VNI-West Consultation Report - Options Assessment

This document has been prepared by Simon Bartlett and Bruce Mountain and is submitted to the AEMO Victorian Planner (AVP) and TransGrid, pursuant to their invitation for submissions on the VNI West Consultation Report Options Assessment (“Consultation Report”).

Figure 7 Breakdown of cumulative gross benefits for Option 5 under the Step Change scenario

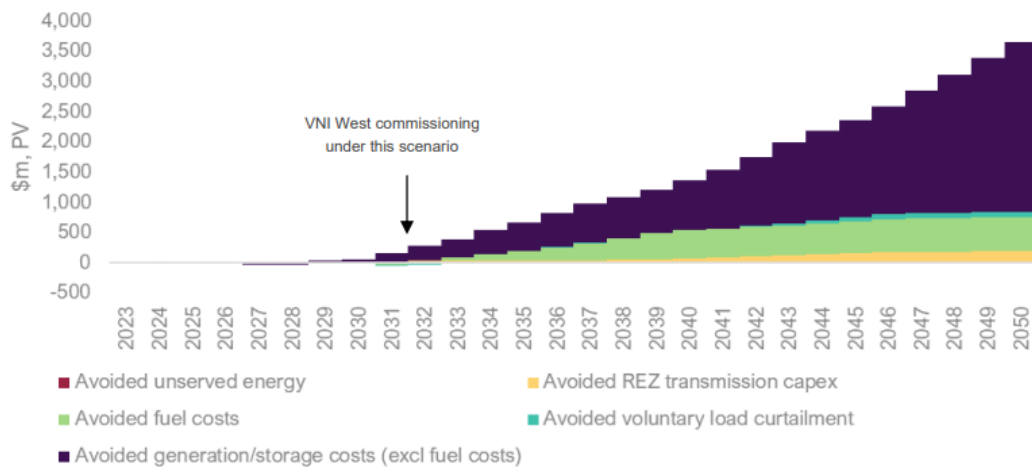
The last three categories combined, reach around \$400m PV by 2040, but somehow grow to \$800m by 2050.

Appendices B, C, F and G provides evidence and reasoning to conclude that the claimed market benefits arise from non-compliances with the National Electricity Law and National Electricity Rules, a completely implausible Base Case and extreme VNI West/WRL congestion causing huge spills of renewable energy attributable to AVP’s assumption that vast amounts of new PV and wind power are installed in the REZ’s along the path of WRL/ VNI West.

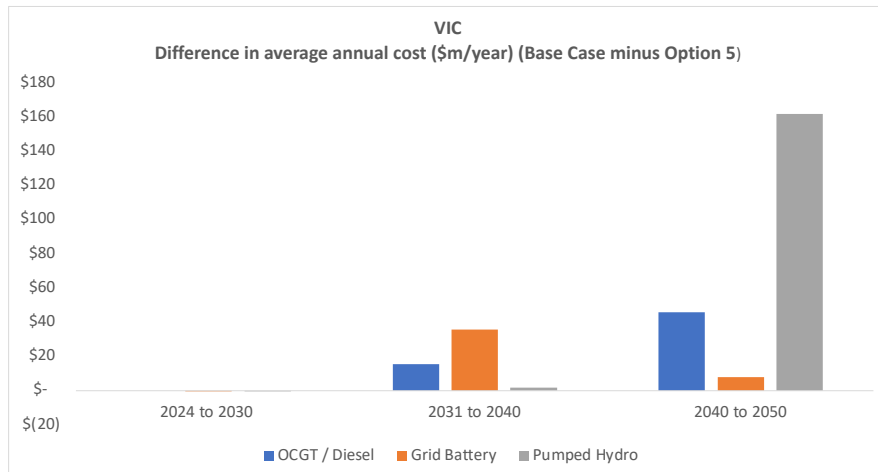
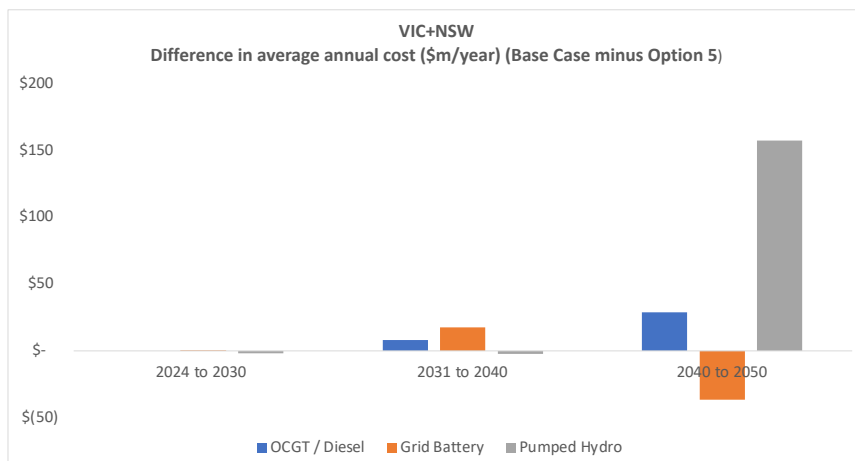
The claimed “avoided generation/storage costs” which accounts for 75% of the claimed benefit, bears particular scrutiny. Understanding this is very important in understanding AVP’s conclusions. Below we reproduce Figure 2 from Appendix B. The figure shows the difference in the annual average annual cost (\$m/year) in Victoria for Base Case minus Option 5 for OCGT/Diesel, Grid Battery and Pumped Hydro 2024 to 2050. To produce this chart we have used AVP’s model outputs on the difference in capacity and priced it at an annual cost we calculated using AEMO’s 2022 ISP assumptions on cost of capital, asset life and fixed operating costs. The chart shows that the main effect of building WRL-VNI is to reduce expenditure on pumped hydro by \$160m per year on average over the decade from 2040. It also reduces expenditure on OCGT and batteries but in both cases by much less than on pumped hydro.

Analysis of the differences between Option 5 and the Base Case in each NEM region, reveals that, as expected, WRL-VNI also has a big effect on NSW. We can see the net effect of WRL-VNI on NSW and VIC by adding the numbers shown in the figure above, for NSW and VIC. This is shown in the figure below.

What we see in this figure, and comparing it to the previous one, is that WRL-VNI reduces expenditure on pumped hydro in Victoria (by about \$160m per year) and replaces it with more expenditure in NSW (about \$35m) per year in NSW. We can see from this that this net difference makes up most of the “Avoided generation/storage costs” which as noted repeatedly in this submission is 75% of AVP’s estimate of the total benefit of WRL-VNI.

5.1.2 Understated WRL Uprate cost

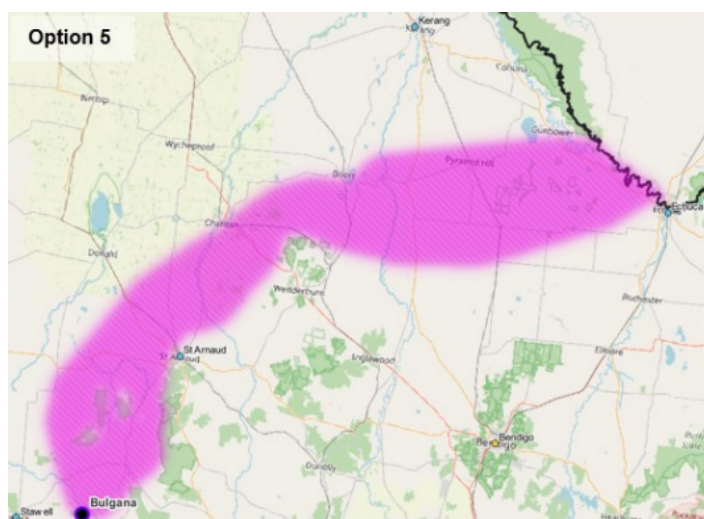
Appendix A.2 of the Consultation Report “Cost estimating methodology for the VIC components” confirms that there is no risk allowance in the VIC 500kV transmission line cost estimates which are based solely on TCD cost estimates. The only allowance for a contingency above the TCD cost estimates is in estimating the WRL uprate costs, however in that case the contingency has been incorrectly applied as shown below. The incremental costs attributed to VNI West for uprating WRL has been calculated as follows:

“To estimate these costs, the per kilometre cost for the current 220 kV line was subtracted from the current market cost for the 500 kV line, while still accounting for known risks by means of an added 30% contingency. The higher voltage line will also require a wider easement[.]”
Reference from Consultation Report

The correct calculation would be to first increase the TCD cost estimate for the 500kV line by 40% (to allow for adjustments and overheads as well as known and unknown risks) subtract AusNet’s costs for the 220kV line no longer required (noting AusNet would have included appropriate contingencies in their contract sum), add in the cost of the additional Waubra 220 kV works and AusNet’s required profits for the uprating and any wasted expenditure on the 220kV line works. The approach used has omitted the 40% contingency required for TCD cost estimates for a 500kV line (i.e., 40% of \$2.91m/km for 104kms (i.e., \$121m), only added a 30% contingency on the difference between AusNet’s price for the 220kV line and the TCD price for 500kV (i.e., \$32m), has omitted the cost of the Waubra works for Option 5 (\$20m?) and it’s unclear how or where AusNet’s wasted expenditure to date and their required profit margin is included. The \$315m allowed in Option 5 appears to be understated by at least \$109m and it is impossible to check how much has been included for the last two items due to the lack of transparency and the use of incremental costs instead of the full cost as required in the RIT-T instrument.

Figure 55 Areas of interest for indicative alignments

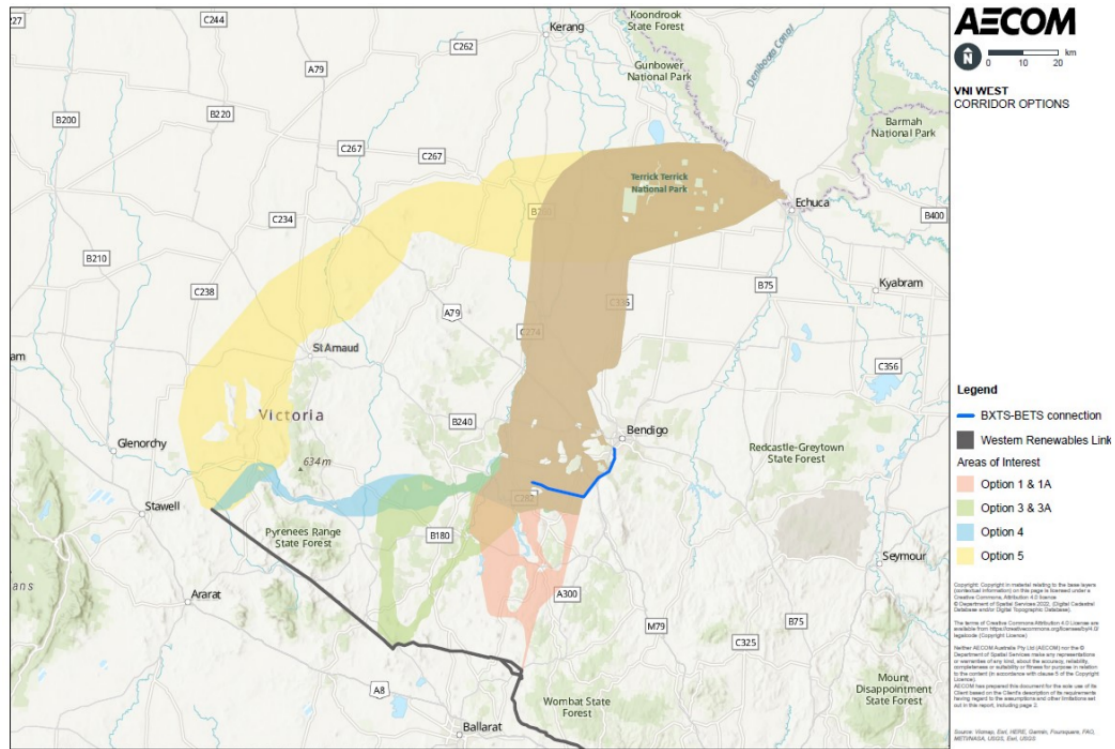
Figure 55 from the Consultation Report, repeated below shows clearly that option 5 is much longer than option 1. Using the scale on this figure, the total length of the 500kv lines between Ballarat and the border crossing point downstream of Euchuca is ~335km via WRL and option 5 compared with a ~189km for option 1. The additional 146km would cost \$m596 at \$m4.08/km. This is the increased cost of the 500kV transmission lines from moving the WRL/VNI West connection point from Ballarat to Bulgana. The blue line in figure 55 appears to be a new 35km long 220kV transmission line between

the new Bendigo 500kV/220/kV substation (BXTS) and the existing Bendigo 220kV substation (BETS).

The following table compares the 500kV route lengths in Table 5 of the Consultation Report with the route lengths determined by the three independent assessments. It appears that all options except Option 5 have been over-estimated by 36km to 48km and that Option 5 has been under-estimated by 23 km. Every local knows that Bulgana is further away from the crossing point near Echuca, than North Ballarat or Walcha, and knows that the lengths in Table 5 are clearly wrong. Costing the difference in length for each option at the NSW 500kV line cost of \$4.08m / km results in the cost differences in Table 4 below.

5.4 Under-statement of VIC Substations Costs

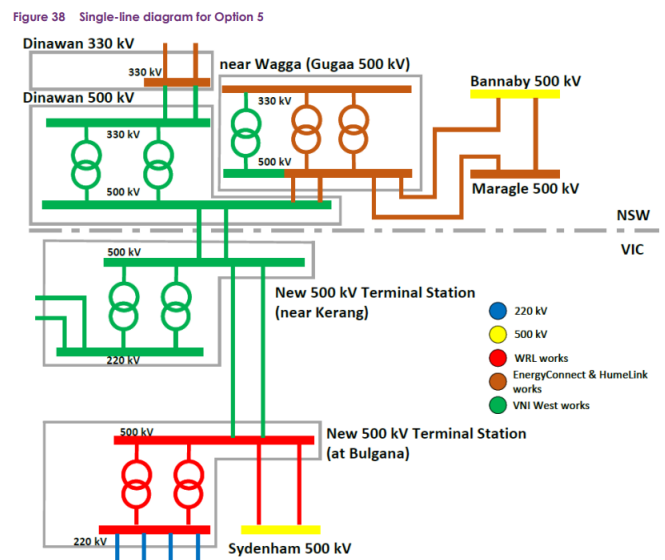
Table 5 of the Consultation Report claims that there are no new substations required in NSW and only one in VIC yet the estimated cost of VIC substations in Option 5 is \$418m compared with \$354m in NSW. In truth, a new 500kV substation is required at Dinawan and two new substations (a 500kV substation and a 220kV substation are required at Kerang, which simplistically, would result in the VIC substation costs being twice the NSW substation cost (i.e., \$708m being twice \$354m compared with the \$418m in Table 5. A closer look below of the required scope of substation works for Option 5 confirms that the VIC works are much greater than the small cost difference implies:

- a. Gugga and Bulgana substations have similar scope of works as both require two additional 500kV switching bays and reactors. Gugga also requires a transformer. Bulgana appears to require four outgoing 220kV feeders shown in blue not required at Gugga or North Ballarat, but it is unclear what their purpose is in the Consultation Report. Bulgana substation may also be required to provide the additional land and various services to the series compensation facilities.

- b. Dinawan requires the establishment of the brown fields 500kV substation with two transformers adjacent to the PEC 330kV substation.
- c. Kerang requires green-field 500kV and 220kV substations requiring extensive excavation and civil engineering works with two transformers, with an access road, auxiliary power supplies, water supply, emergency diesel generators, duplicated telecommunications facilities and security fencing none of which are required at Gugga or Dinawan. It also must provide connections and services to the series compensation at Kerang and the 220kV power flow controllers. These substation servicing costs will be in addition to the costs of the power flow controllers and series compensation and their additional substation costs in Table 5. It is estimated that these additional works would easily add more than \$25m to \$50m to the equivalent brown-field substation costs in NSW.

- d. There are also the additional costs of redesign, scope change, relocation and plant storage costs to vary the existing contract with AusNet Services to enable relocation of the North Ballarat substation to Waubra or Bulgana. Based on the difference between the substation costs between options 1 and 3, these variation costs appear to be around \$63m. This alone accounts for the \$64m difference between the NSW and VIC substation components, without allowing for the large scope difference at Kerang described above.

The Consultation Report explains that the VIC substation cost estimates come from the TCD, and there is no evidence that the required 40% contingency has been added for adjustments and risks, as was included in Table 3 of the AEMO updated WRL assessment. The inclusion of the required 40% alone would increase the \$418m to \$585m adding \$167m. Including the \$25m in (c) above would take the total under-statement of VIC substation costs to at least \$192m bringing the total cost of VIC substations to at least \$610m which is 1.7 times the \$354m NSW figure. This is considered to be a reasonable comparison given that two substations are required in VIC and only one in NSW as well as the increased scope of work in (c) above.
